Manual 12, Balancing Operations

Revision 57 – Annual Review

Markets and Reliability Committee
April 22, 2026

Revision 57 (05/26/2026):

- Removed “Dispatching Timeline” exhibit and supporting language.

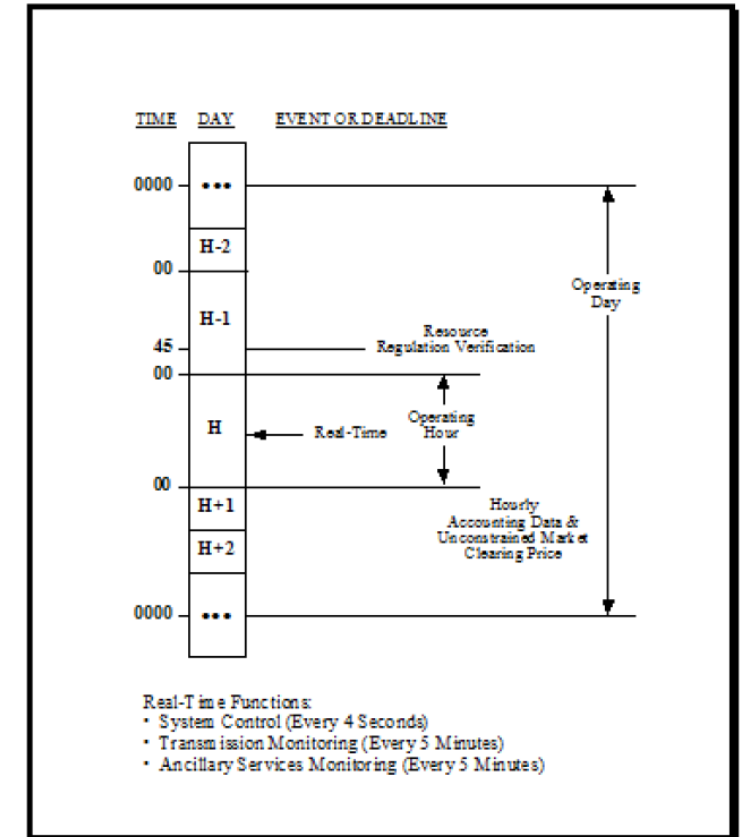
In PJM Manual 12, Balancing Operations, we focus mainly on the Dispatching Operation activities that take place in the current hour of the Operating Day. ~~The following exhibit presents the dispatching activities in the form of a timeline. The reference point for the timeline is the Operating Day, the daily 24 hour period beginning at midnight for which transactions on the PJM Interchange Energy Market are scheduled. This timeline type of description is used throughout this PJM manual.~~
